ADDENDUM NO. 02
January 20, 2022

To Drawings and Specifications dated December 17, 2021

CLINE ELEMENTARY SCHOOL CAMPUS REPLACEMENT
FOR FRIENDSWOOD I.S.D.

Prepared by: PBK
11 Greenway Plaza, 22nd Floor
Houston, TX 77046-1104
PBK Project No: 20380

B:\2020\20380\Div6-Dwgs\8a BIM CAD\02 Civil\Dwgs\C 301 PAVING AND GRADING PLAN.dwg Last Saved: KFALKE
Wednesday, January 19, 2022 7:39:35 AM
DRAWN BY: AGLUZMAN
CHECKED BY: KFALKE

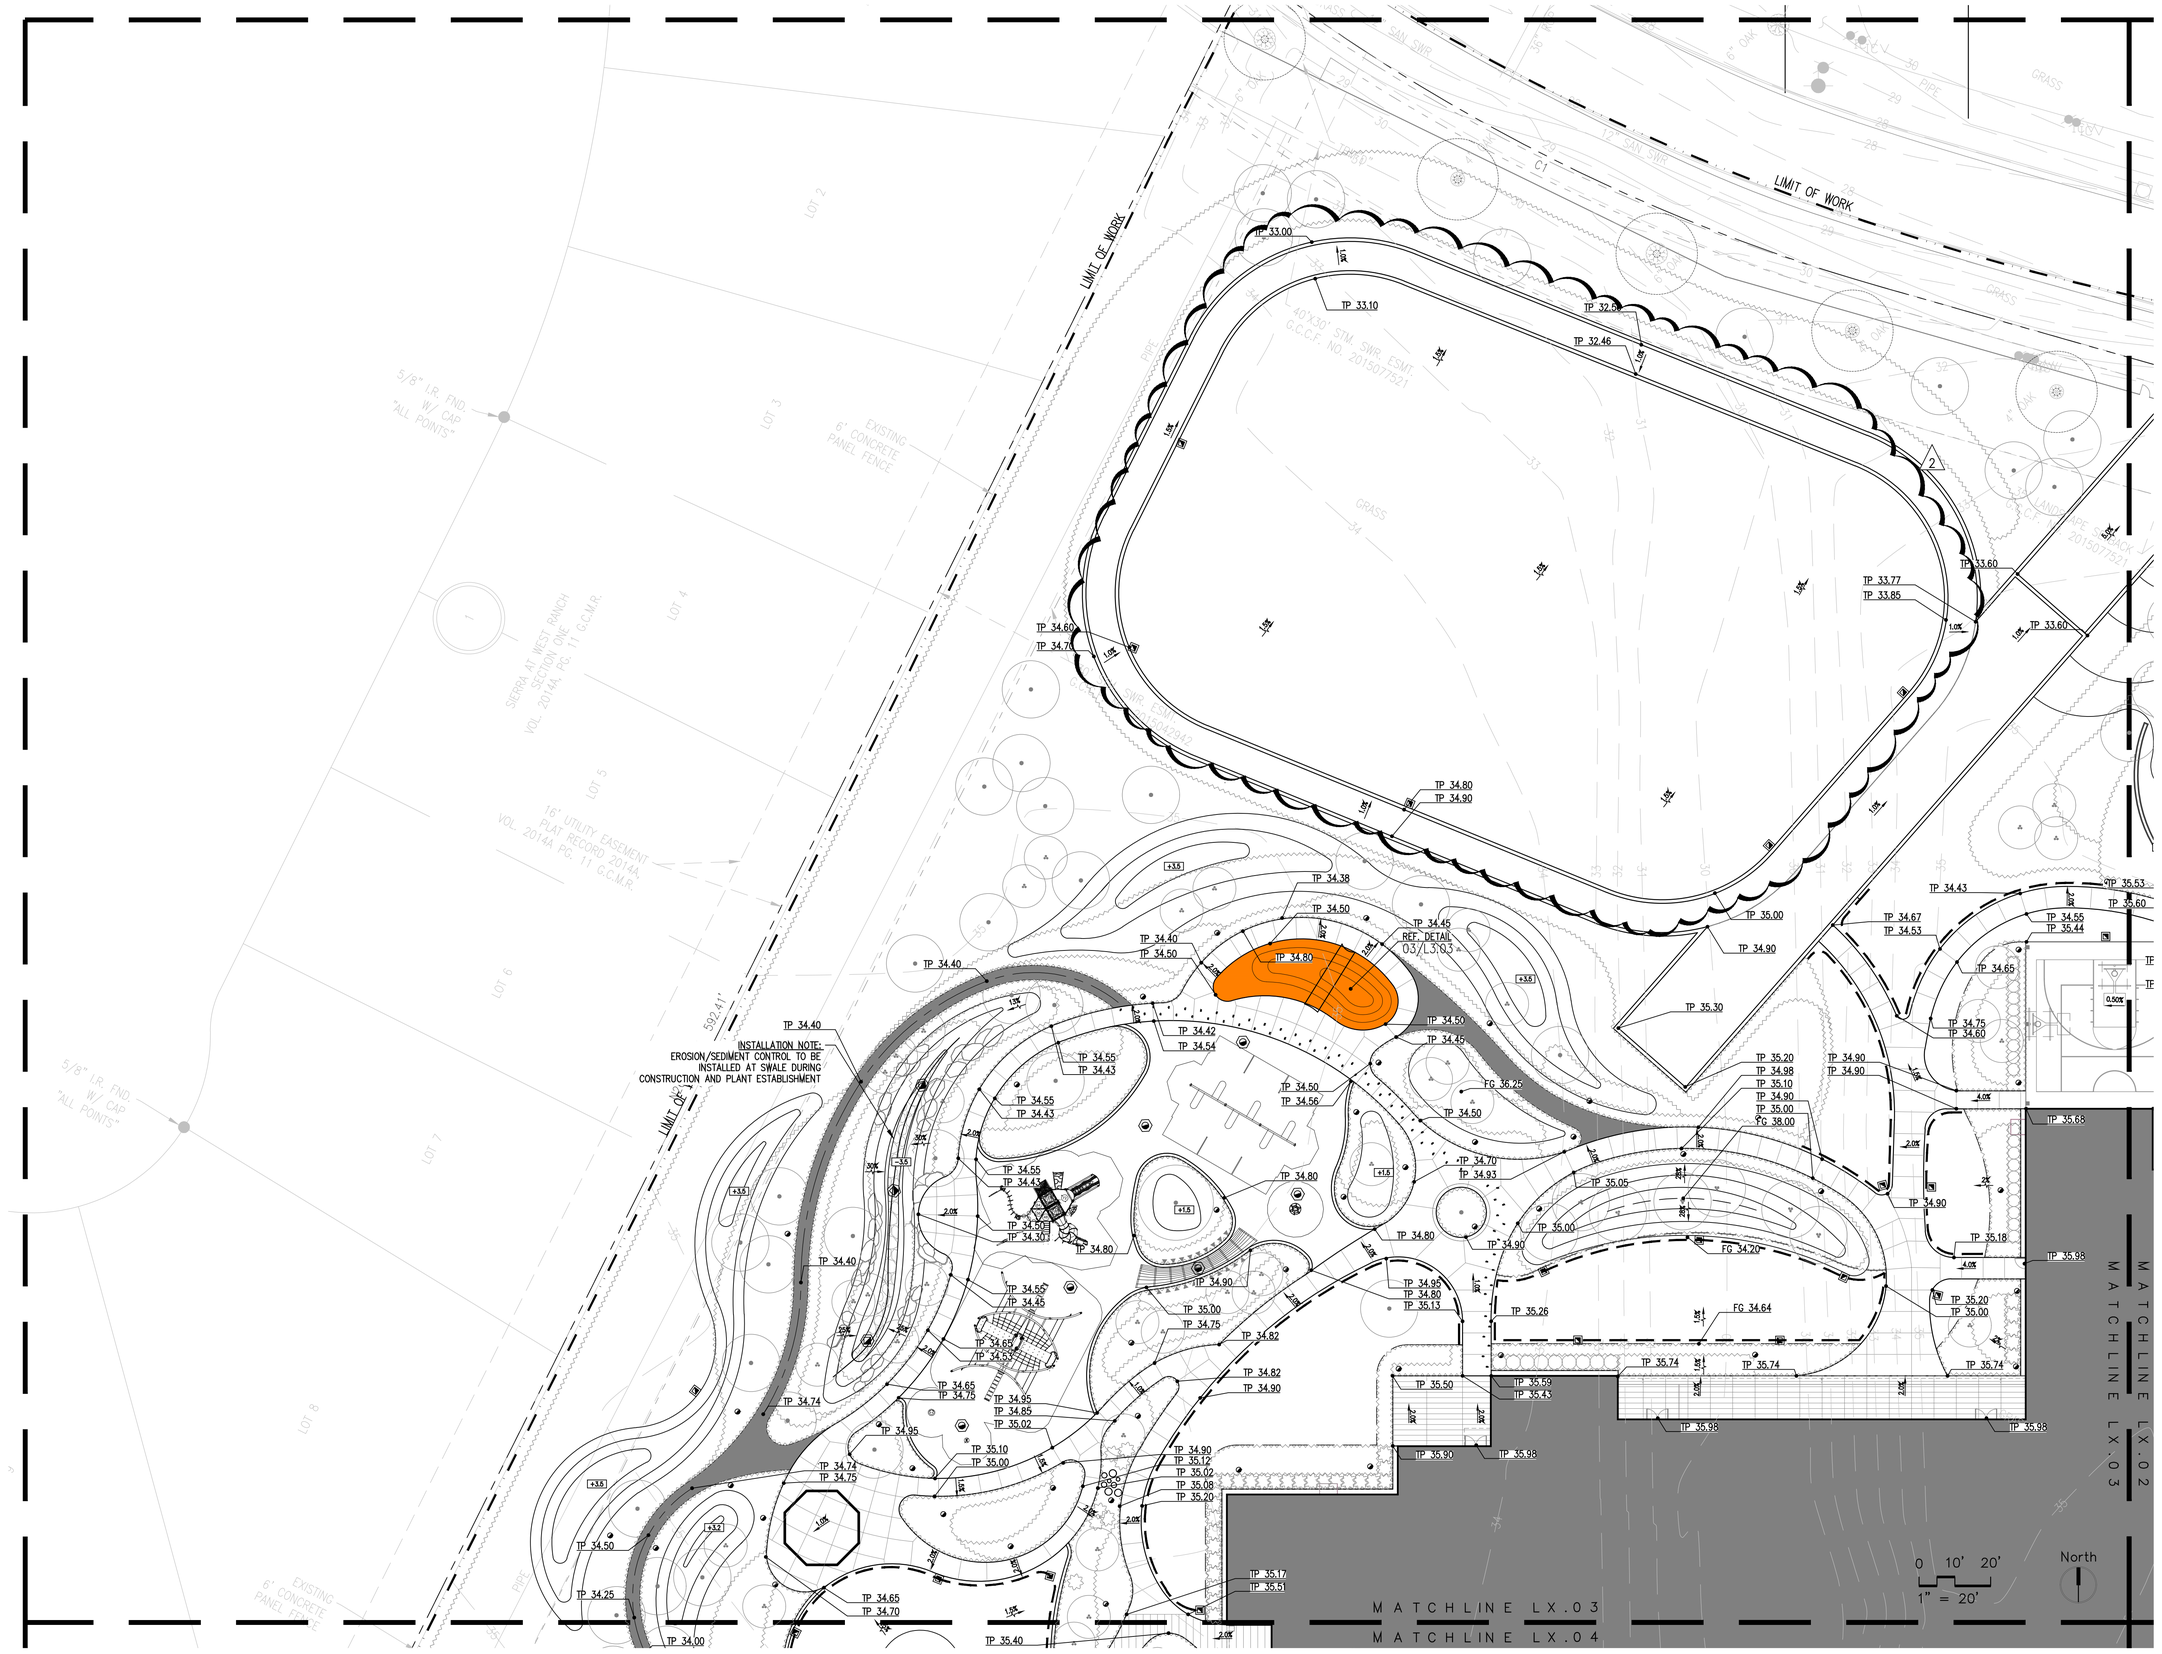
Provide information for the medium duty asphalt paving shown on C-301. Asphalt paving is not shown on C-501 or C-502. Do the asphalt track details on C-506 apply to the asphalt fire lane paving shown on C-301? Details for the track show 12" stabilized subgrade, 8" crushed limestone base, and 3" asphalt (HMAC). Does the same concrete track curb also apply at the asphalt paving for the fire lane?

Do the grass pavers shown on C-301 have a concrete edge / curb? The section detail on C-506 does not show a concrete edge. I would think this does have a concrete edge to receive the fire lane striping shown on C-103.

Yes, the asphalt track details and concrete track curb will apply to the fire lane paving as shown on C 301.

Yes, a 12" concrete border in shown in the landscape drawings.

3 SECTION AT BALCONY
3/4" = 1'-0"

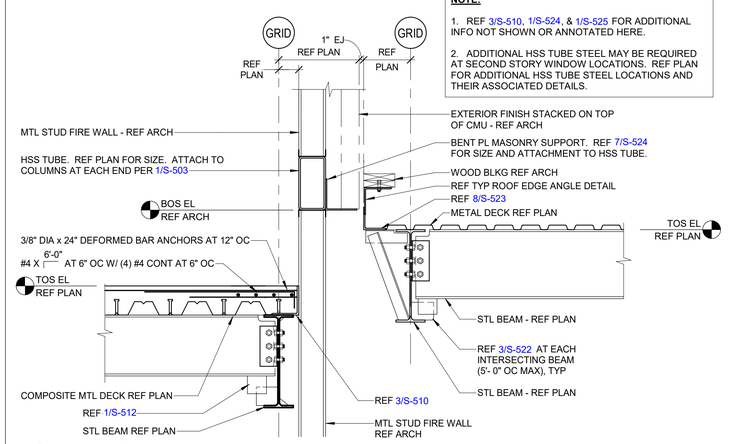
a. Details 1, 2, 4, 6, & 8 revised. See revised sheet.

03 ENLARGED FLOOR PLAN - STAGE RAMP
1/4" = 1'-0"

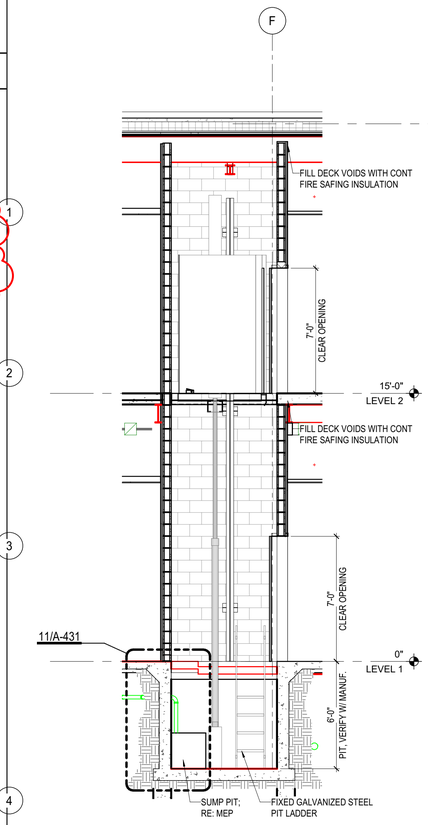
a. Revised details 03, 10, 13, 14 and 15
b. Revise room finish schedule

15 OUTDOOR SEATING SECTION @ CIP RETAINING WALL (ALTERNATE #9) 2
1" = 1'-0"

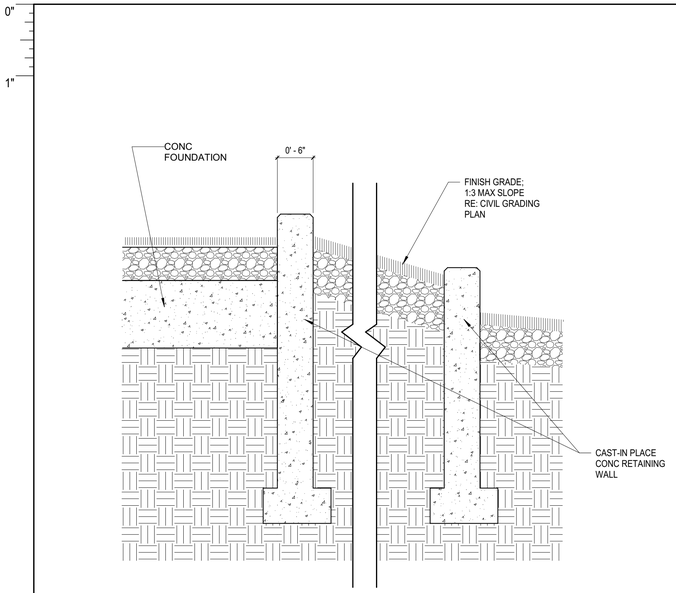
a. Revised name for details 05, 10 and 15 to Add "Alternate #9"
